The Commission has issued the enclosed Amendment No. 48 to Facility Operating License No. DPR-67 for St. Lucie Unit No. 1. This amendment consists of changes to the Technical Specifications in response to your applications dated November 14, 1980 and September 28, 1981.

The amendment changes License Condition 2.C.(1) and the Technical Specifications to authorize operation of St. Lucie Unit 1 at 2700 Megawatts thermal power. The previously authorized maximum power level was 2560 Megawatts thermal.

ST. LUCIE PLANT UNIT NO. 1

Amendment No. 48
License No. DPR-67

Figure 2.1-1 REACTOR CORE THERMAL MARGIN SAFETY LIMIT - FOUR REACTOR COOLING PUMPS OPERATING

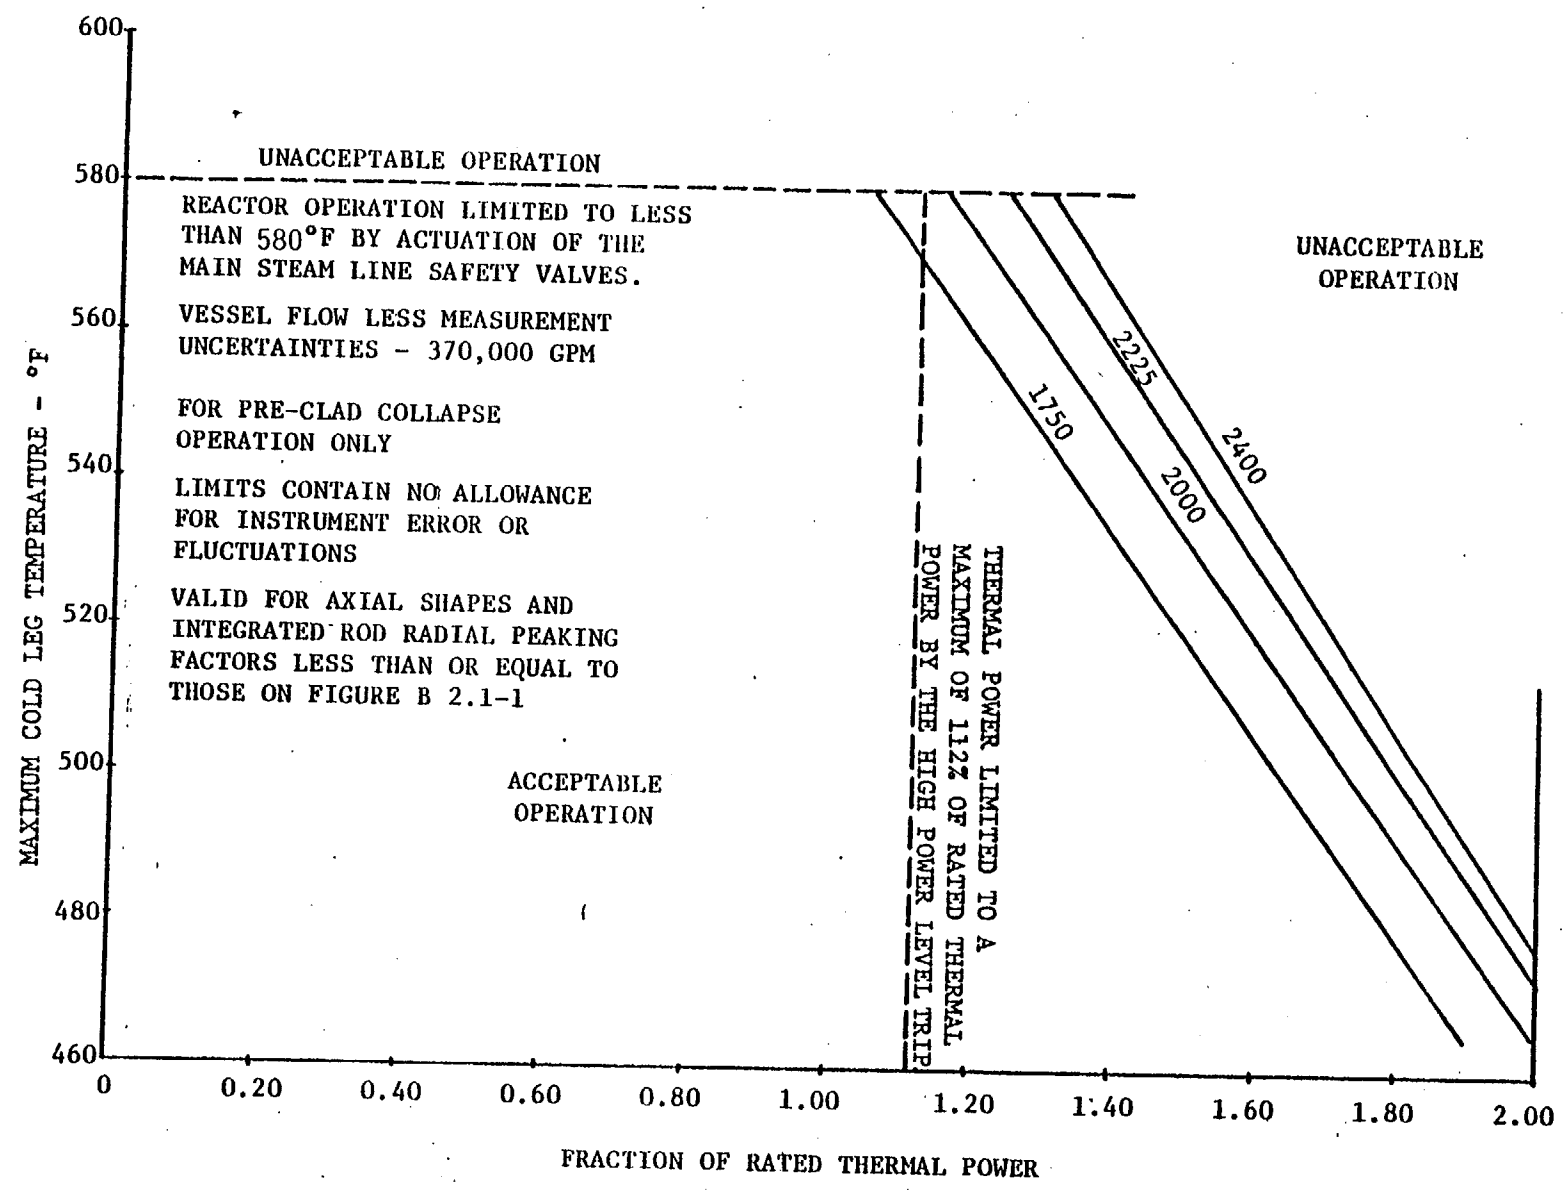
Technical Specification Figure 2.1-1, page 2-2

These proposed modifications to the Technical Specifications in Section C.4 have been reviewed by the staff and are acceptable.

FIGURE 2.2-2
Local Power Density-High Trip Setpoint Part 2(QR_2 Versus Y_1)

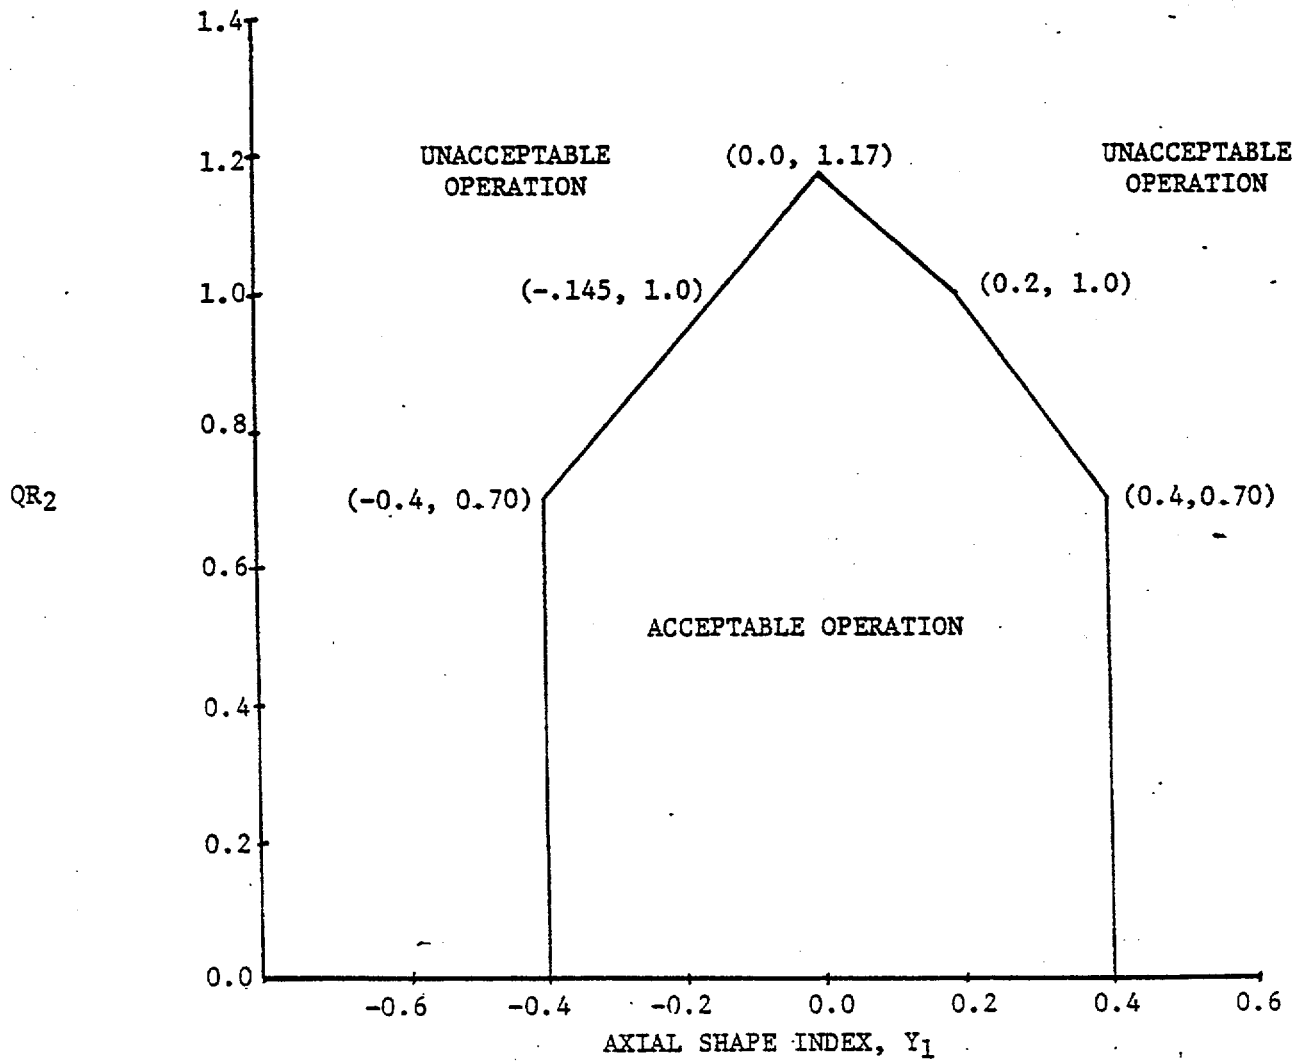
The Local Power Density Limiting Safety System Setting has been changed to reflect operation at 2700 Mwt with higher radial peaking factors. The trip setpoint has been adjusted to not exceed the limit lines of Figure 2.2-2. The revised Figure 2.2-2 for Local Power Density-High Trip Setpoint is acceptable.

FIGURE 2.2-3

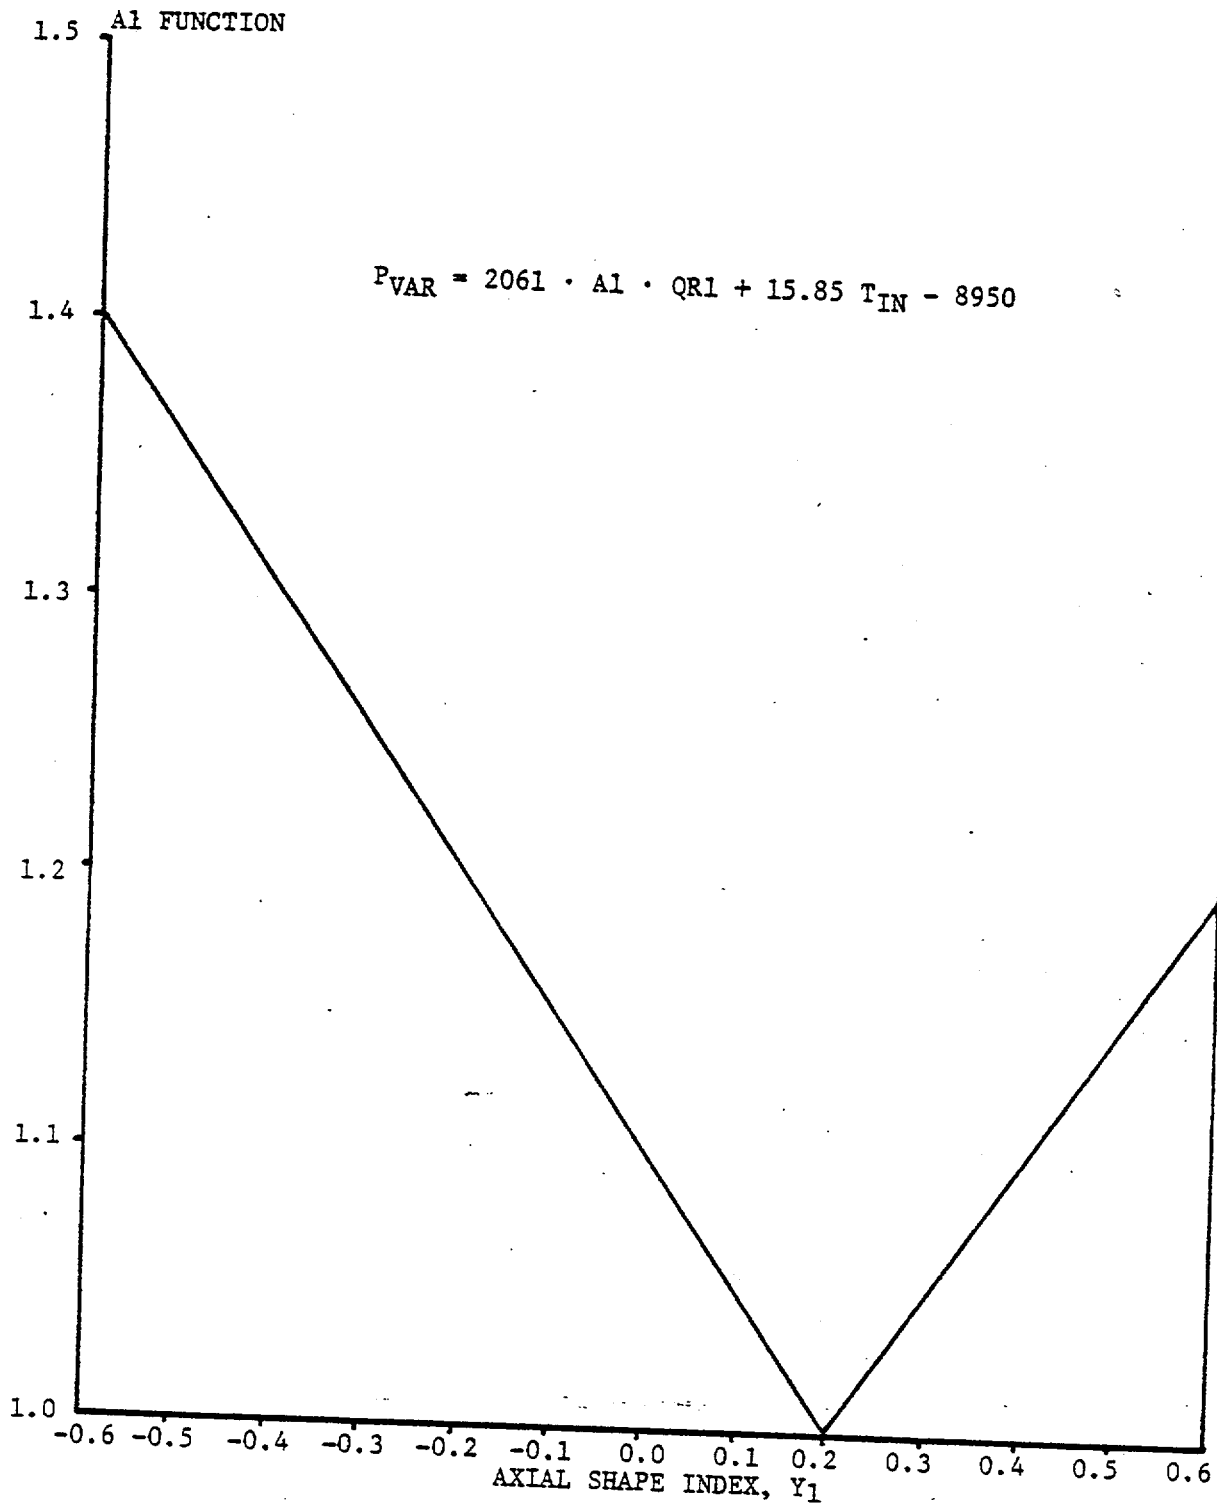
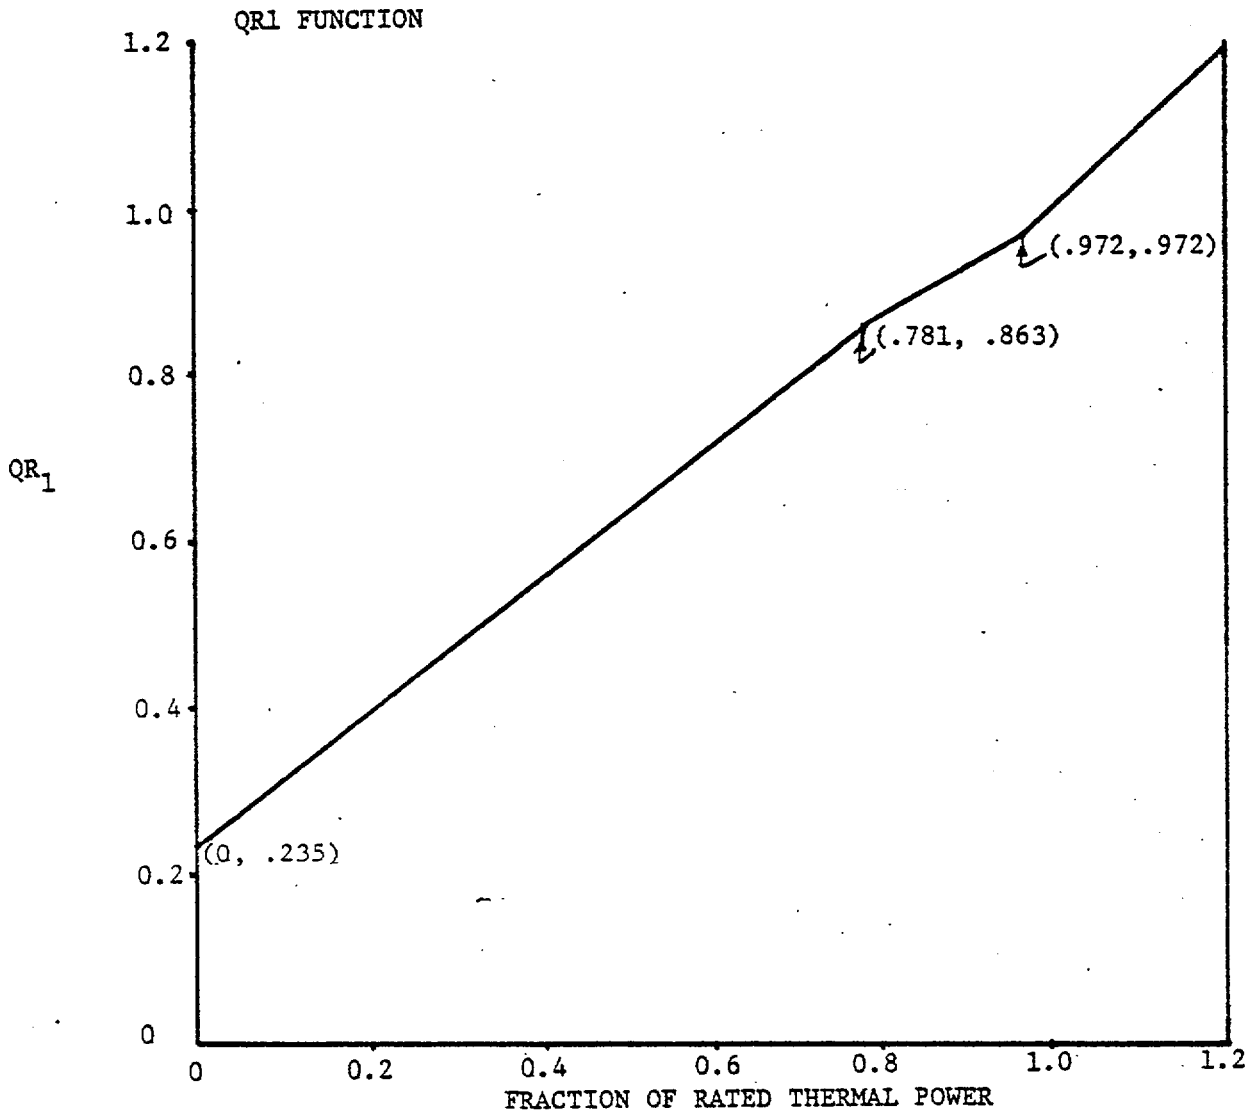
The Thermal Margin/Low Pressure Limiting Safety System Setting has been changed to reflect operation at 2700 Mwt with higher radial peaking factors. The trip setpoint has been adjusted to not exceed the limit lines of Figures 2.2-3 and 2.2-4. These revised figures for Thermal Margin/Low Pressure Trip Setpoint are acceptable.

Figure 3.1-2 CEA Insertion Limits vs THERMAL POWER with 4 Reactor Coolant Pumps Operating

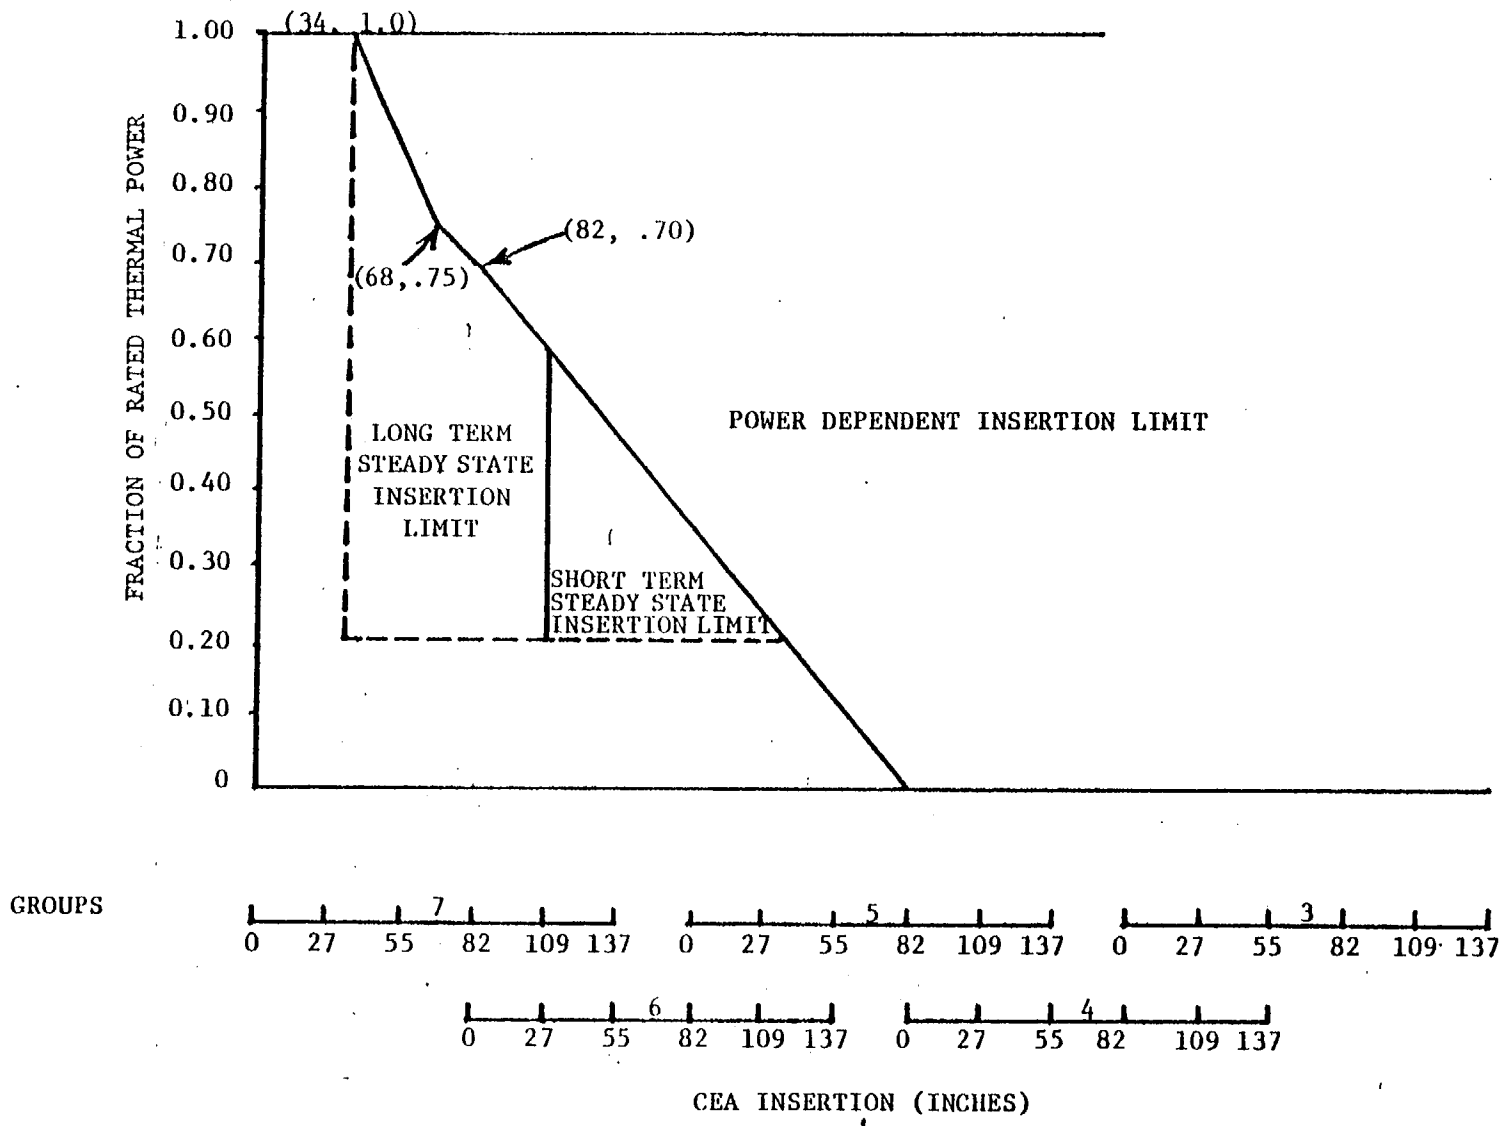
The PDIL is being changed to be consistent with the new LSSS. TS Figure 3.1-2, page 3/4 1-30.

FIGURE 3.2-1 Allowable Peak Linear Heat Rate vs Burnup

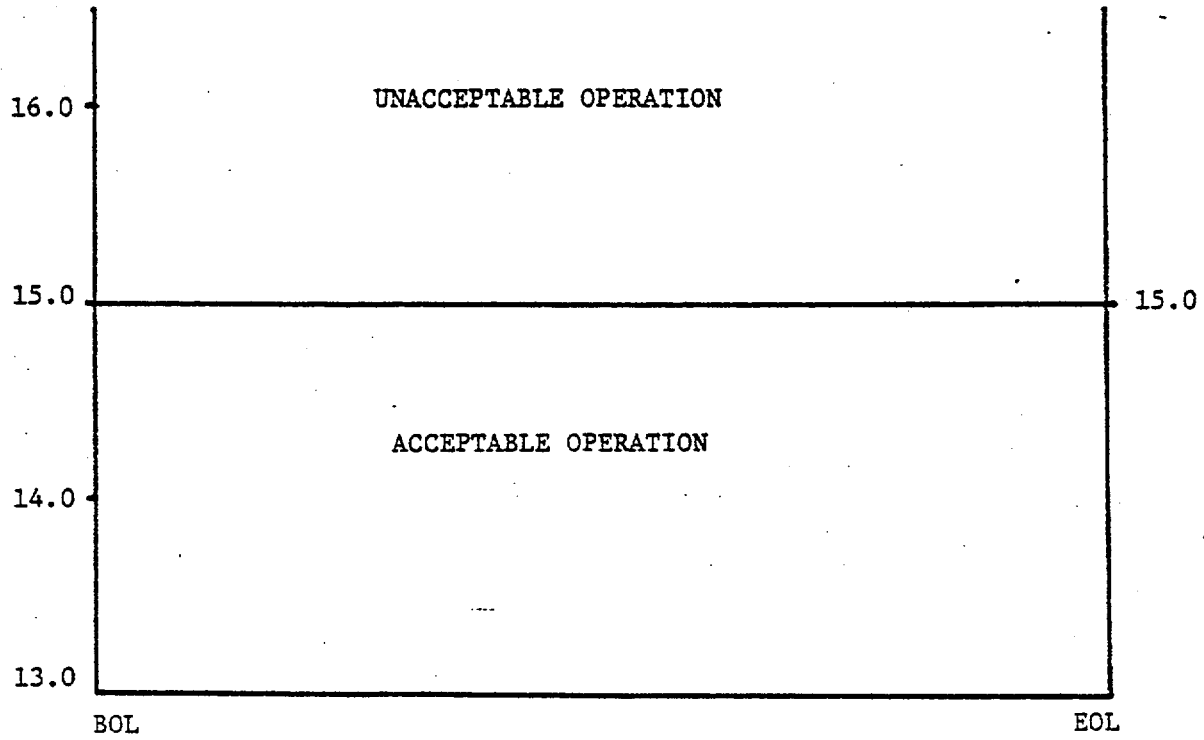
Peak Linear Heat Rate - the allowable peak linear heat rate is increased from 14.68 kw/ft to 15.0 kw/ft to be consistent with the ECCS analysis Technical Specification Figure 3.2-1, page 3/4 2-3.

FIGURE 3.2-2

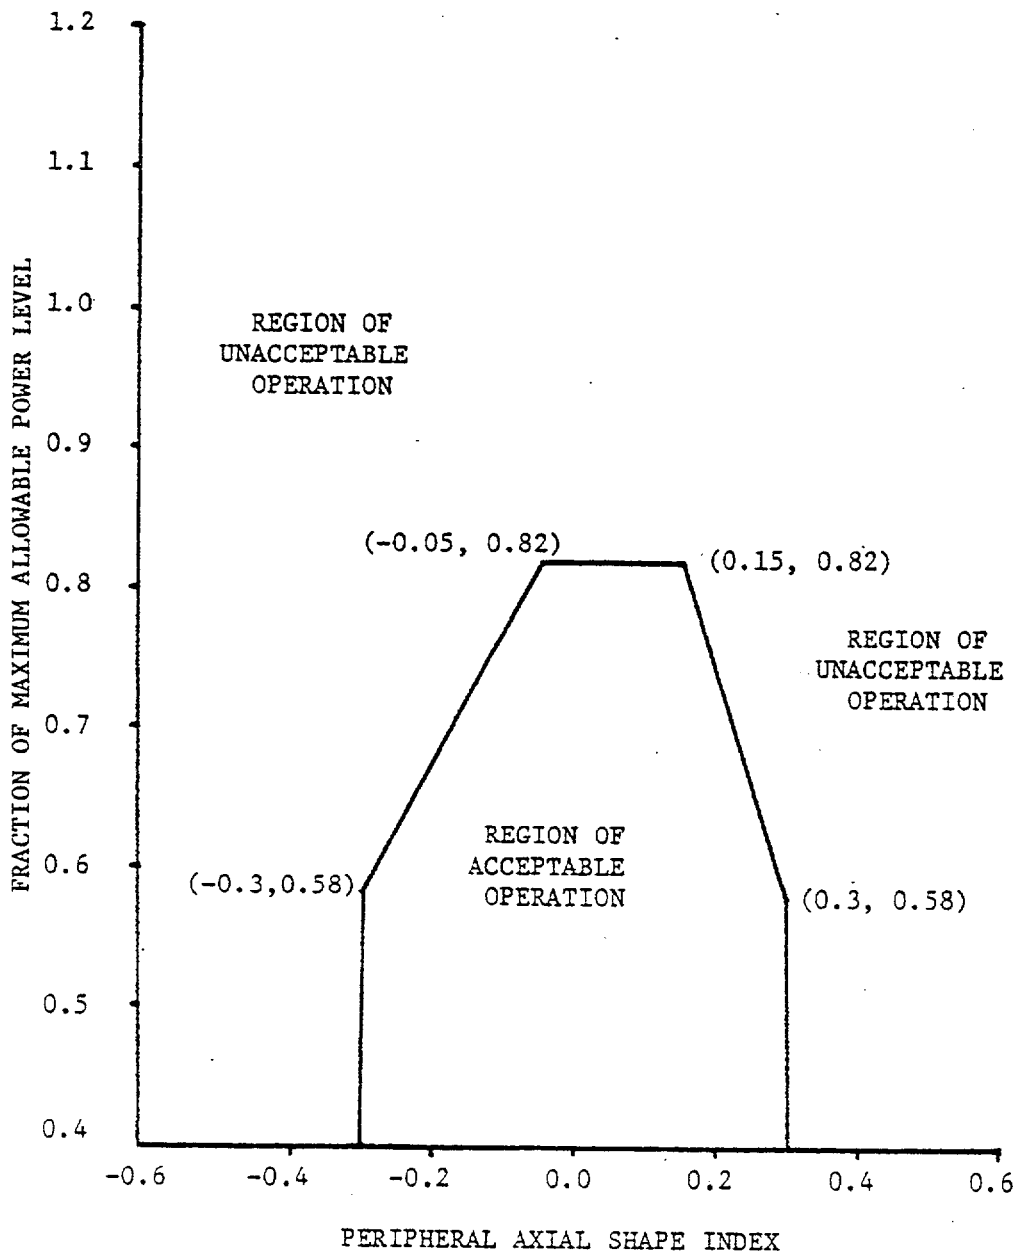
Technical Specification Figure 3.2-2, page 3/4 2-4 and Figure 3.2-4, page 3/4 2-15
